BAINBRIDGE ISLAND LAND TRUST

RE: SR 305 and Day Rd Roundabout Stormwater and Wall/Slope Options and Questions

SR 305
WINSLOW FERRY TO HOSTMARK ST
SAFETY IMPROVEMENTS
DAY ROAD - STORMWATER OPTION 1
(PRELIMINARY)

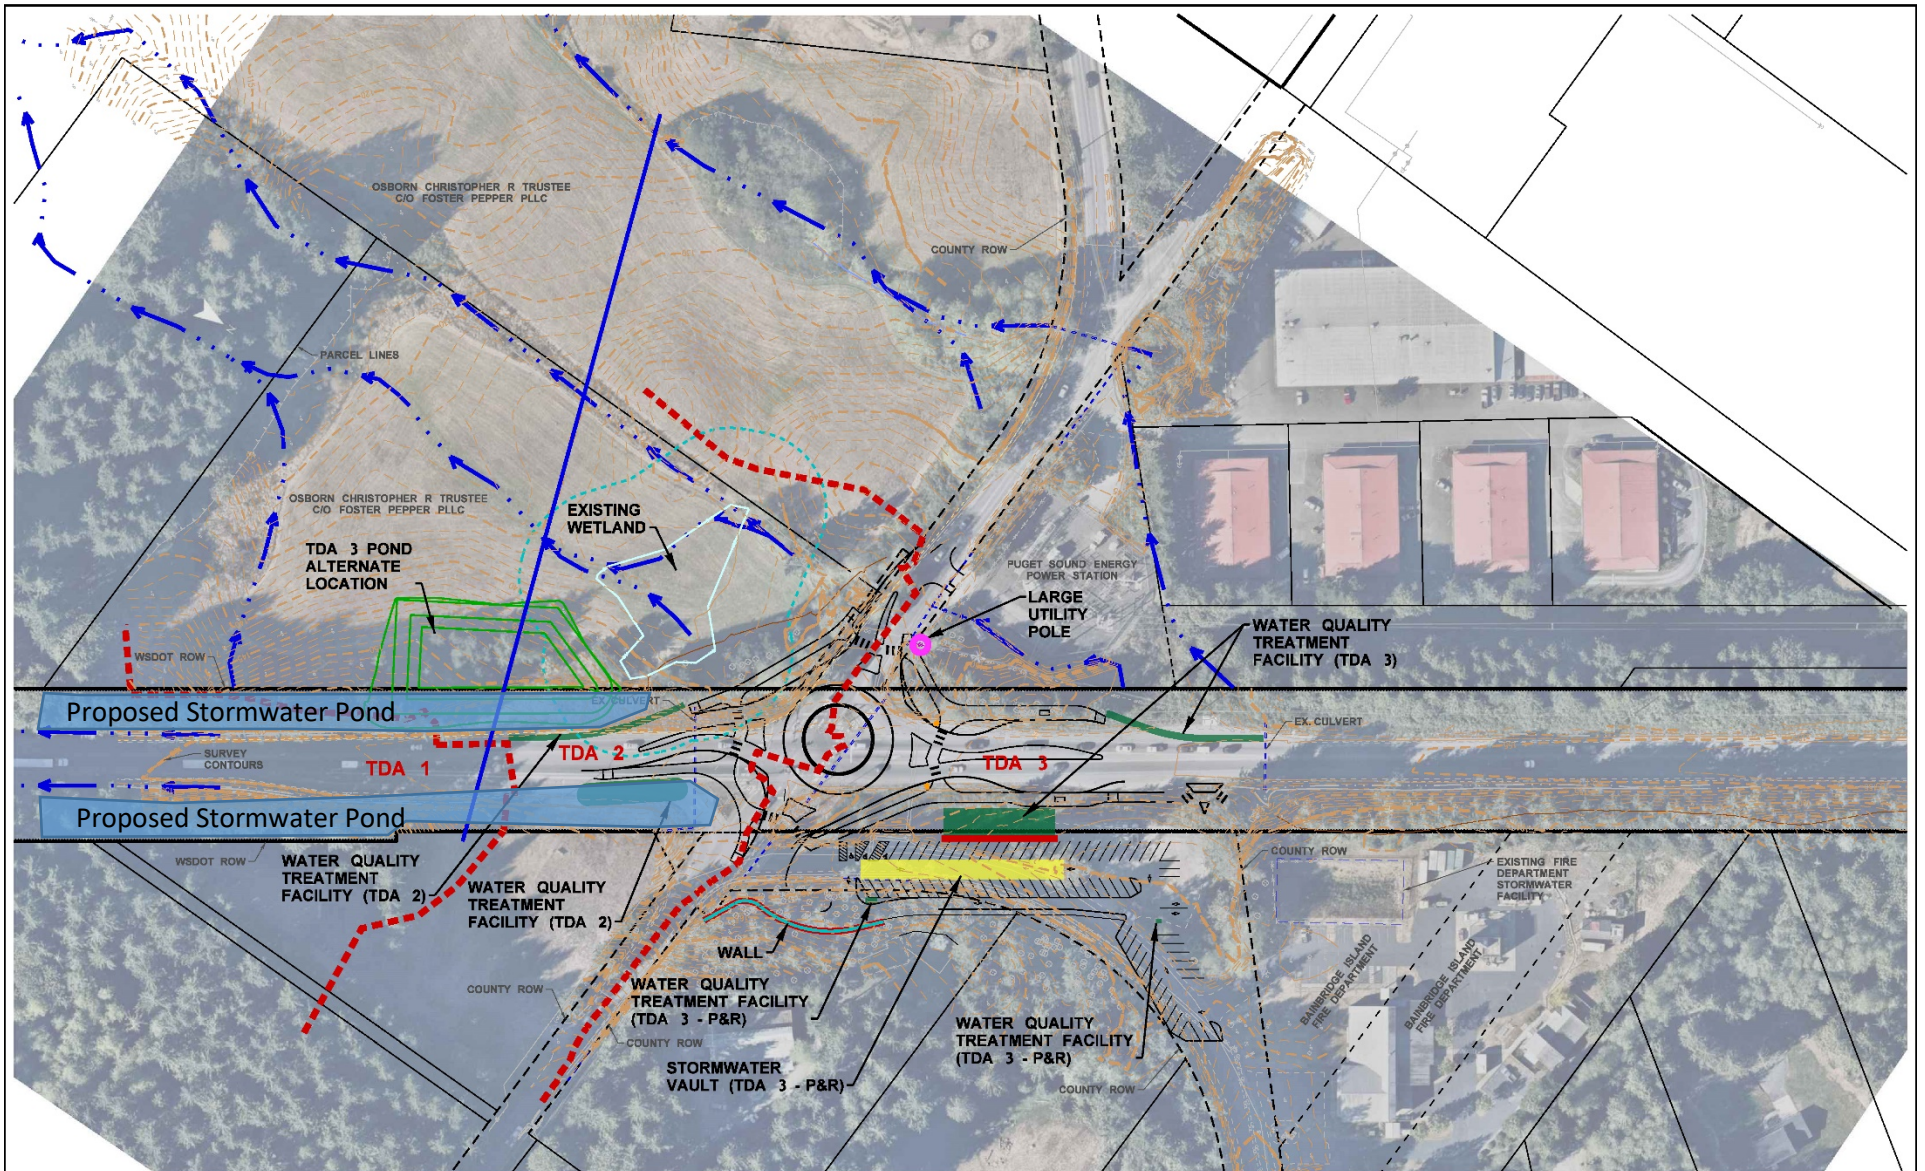
Another factor that influences stormwater design is the requirement that project stormwater needs to be discharged within the same threshold discharge area (TDA) as the pre-project condition. We request that COBI and WSDOT continue discussions with the Department of Ecology (WDOE) about the possibility of allowing stormwater infrastructure within TDA 1 or TDA 2 to disperse stormwater from TDA 3. If WDOE would allow some flexibility in the TDA area, then we believe WSDOT has enough property within its ROW to construct stormwater ponds or vault infrastructure that would eliminate the need for stormwater infrastructure being located on the conservation easement (See Appendix I).

2. WSDOT pursues a TDA exemption from WDOE. If WDOE issues an exemption that allowed the stormwater from TDA 3 to discharge into TDA 2 or TDA 1, this would eliminate the need for a pipe through the conservation easement. If an exemption cannot be issued, rather than a pipe running under the fields in TDAs 2 and 3 between the pond(s) and stream, piping instead might be sited through the WSDOT ROW around the property, which would minimize impacts to the easement and property.
